## **SENIORS LIVING DEVELOPMENT AND DEMOLITION OF EXISTING DWELLINGS AT NOS. 461-473 PACIFIC HIGHWAY, ASQUITH (PANEL REF: PPS- 2018SNH033)**

This letter has been prepared by Urbis on behalf of Chinese Australian Services Society Limited (CASS) (the applicant) to provide additional information to assist the North Sydney Planning Panel (the panel) in determining PPS-2018SNH033 (the proposal).

Figure 4 Impacts of the Increased Basement Clearance Height on Ground Floor Bedrooms

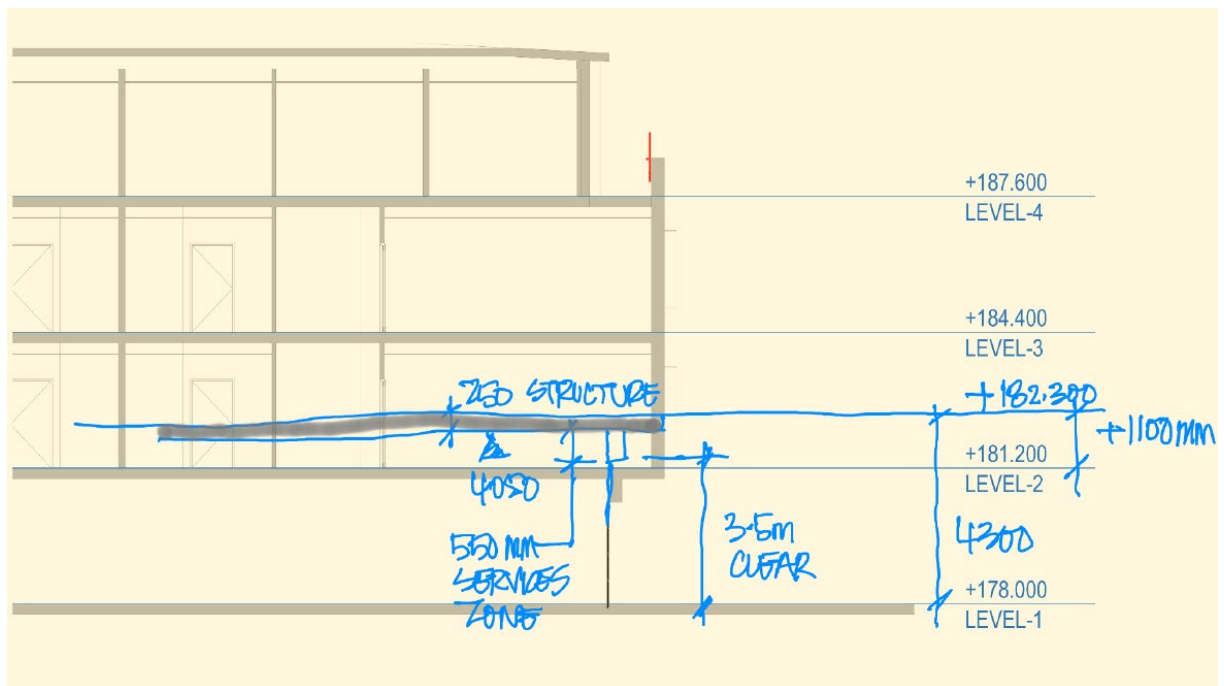
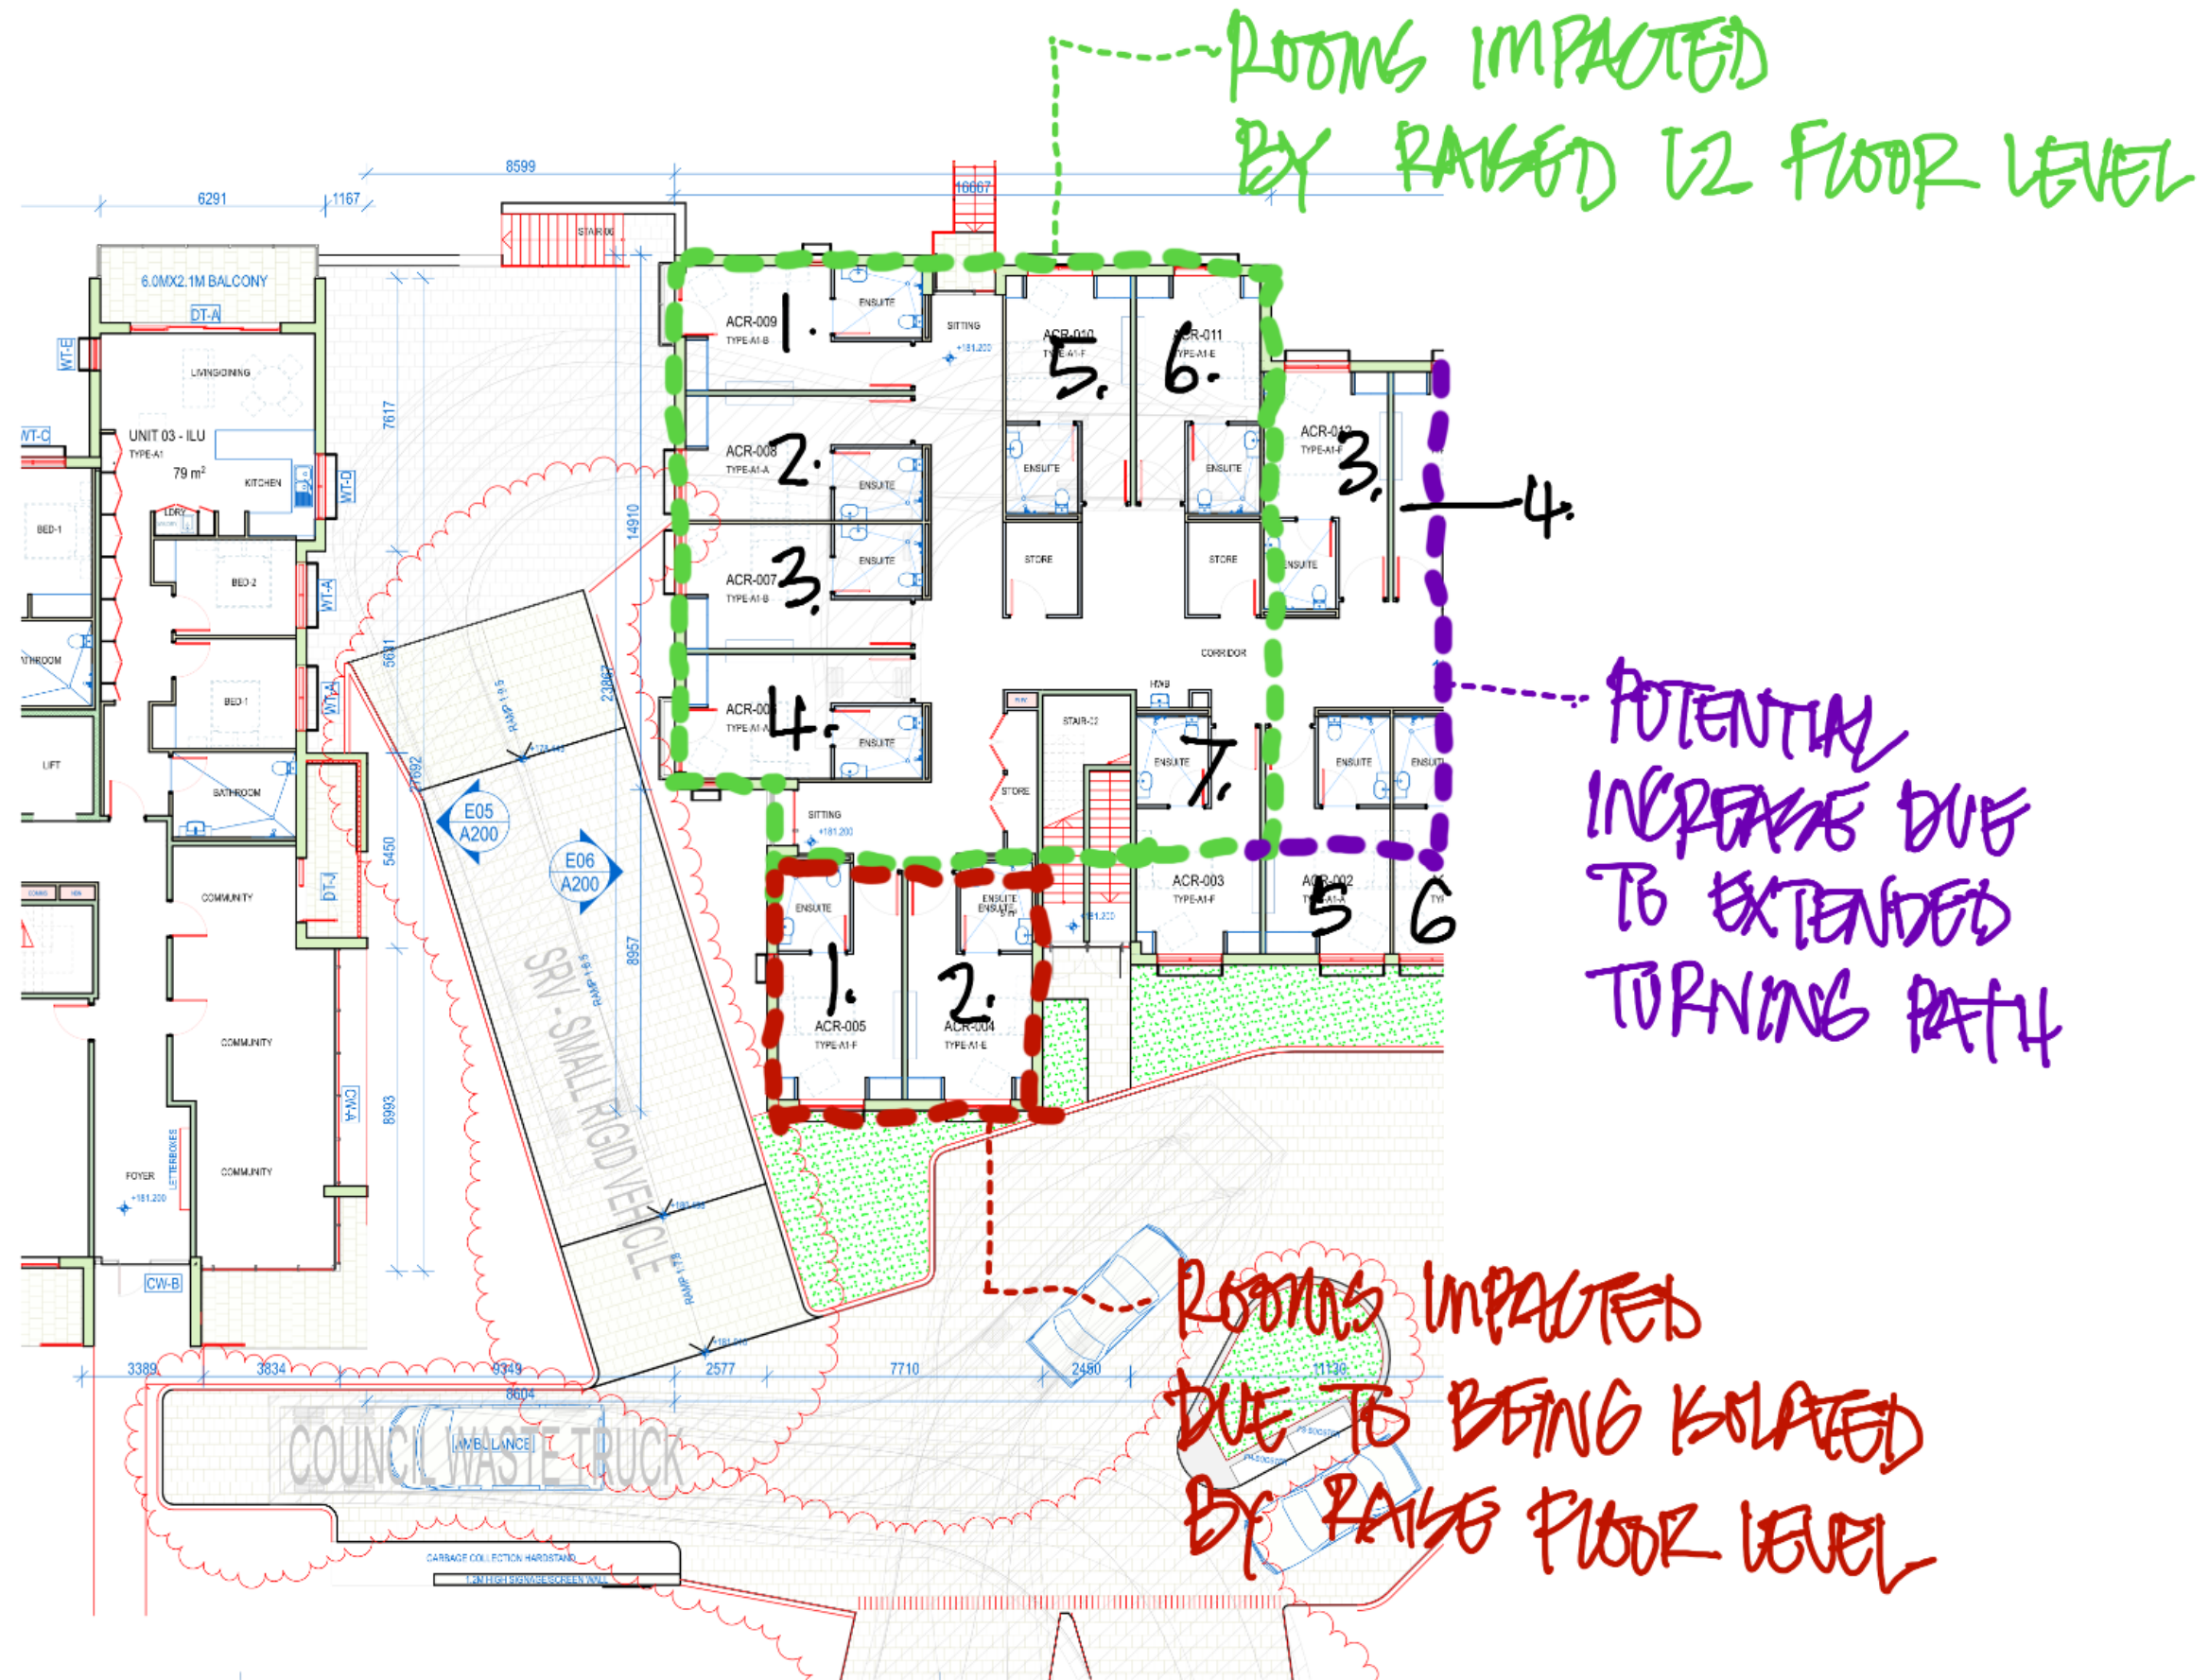
As demonstrated in **Figure 3 – Attachment B3** Council have failed to recognise the swept path of the waste collection vehicle which will increase the extent of the impacts to the RACF bedrooms located directly above the basement entrance.

## Attachment B5 - Impacts of Increased Clearance Height on the Ground Floor RACF Bedrooms - Section

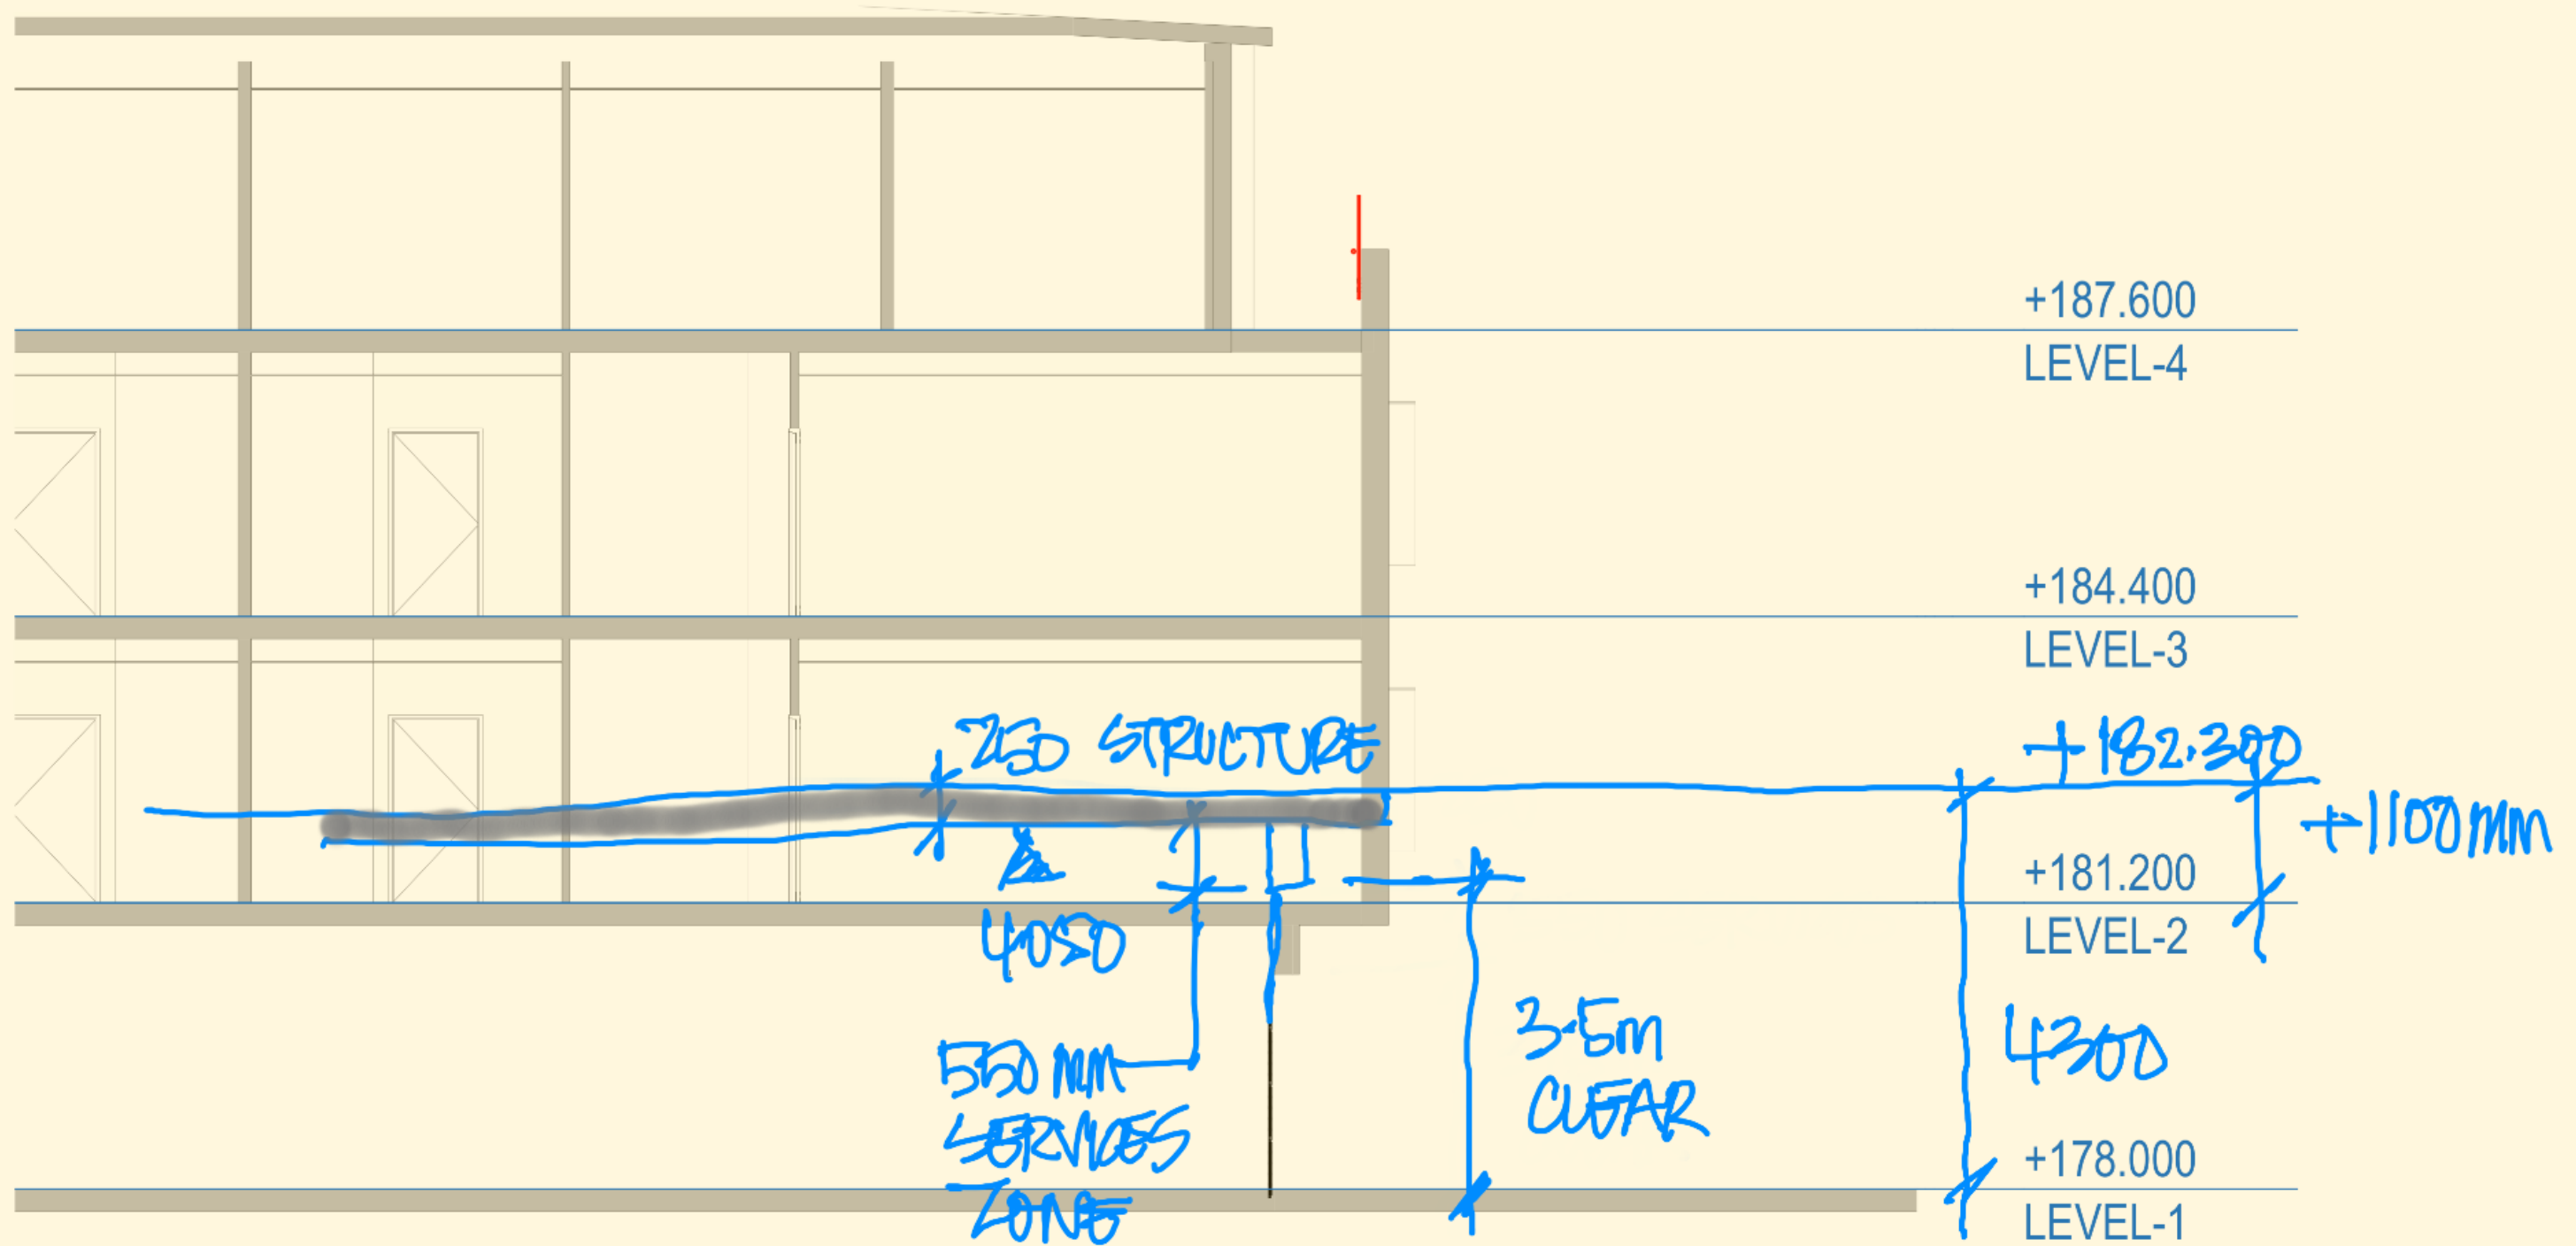
The project architect has diagrammatically reviewed the impacts to the yield of the development should a 3.5m basement clearance be accommodated (refer **Figure 3 – Attachment B3** and **Figure 4 Attachment B4**).
